# Access Compliance Report

## Public Rights-of-Way

Intersection ID: 10033071	Main Street: NORTH_COMMUNITY_HOUSE_RD	Cross Street: N/A	Location: SW
ADA ID: E941219ED651	Ramp Type: Para	Initial Pass/Fail: Fail	Overall Compliance: No
Severity Score: 13.75			
Codes/Mitigation Info/Possible Solution		Field Measurements/Component Compliance

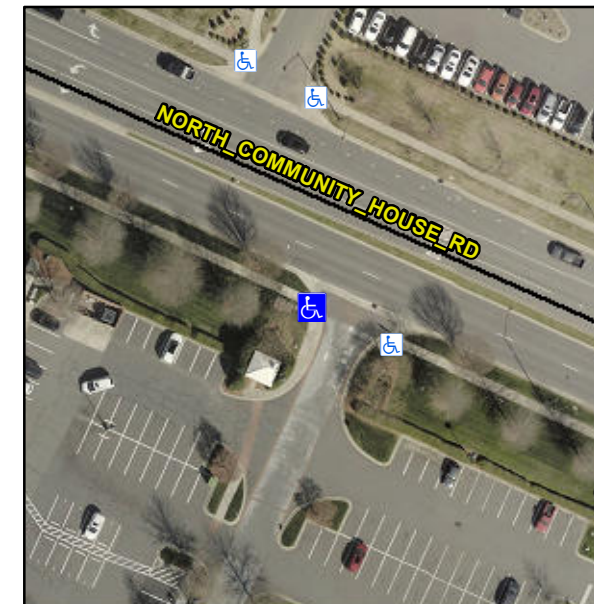
**RT RP < 5%**

**R304.3.2, R304.5.3**

Compliance	Description	Data	Compliance	Description	Data
N/A	Ramp Length LT (in)	77.0	N/A	Ramp Length RT (in)	71.0
Yes	Ramp Width LT (in)	60.0	Yes	Ramp Width RT (in)	58.0
No	Ramp Slope LT (%)	10.3	Yes	Ramp Slope RT (%)	1.4
No	Ramp XSlope LT (%)	2.1	No	Ramp XSlope RT (%)	4.7
N/A	Landing Length (in)	N/A	N/A	DWS Provided?	N/A
N/A	Landing Width (in)	N/A	N/A	DWS Contrast?	N/A
N/A	Landing Slope (%)	N/A	N/A	DWS Length (in)	N/A
N/A	Landing X Slope (%)	N/A	N/A	DWS Full Width?	N/A
N/A	Landing Curb? (Y/N)	N/A	N/A	DWS Offset (in)	N/A
N/A	Shared Landing?	N/A			
N/A	Gutter Ponding?	N/A	N/A	Gutter Slope (%)	N/A
N/A	Gutter Lip Ht (in)	N/A	N/A	Gutter X Slope (%)	N/A
N/A	Painted X Walk1?	No	N/A	Painted X Walk2?	N/A
	X Walk 1 Direction	To SE		X Walk 2 Direction	N/A
N/A	X Walk 1 Width (in)	N/A	N/A	X Walk 2 Width (in)	N/A
	X Walk 1 Slope (%)	4.3		X Walk 2 Slope (%)	N/A
	X Walk 1 X Slope (%)	2.2		X Walk 2 X Slope (%)	N/A
N/A	Ramp inside XWalk1?	N/A	N/A	Ramp inside XWalk2?	N/A

**Remove & Replace Entire Ramp.**
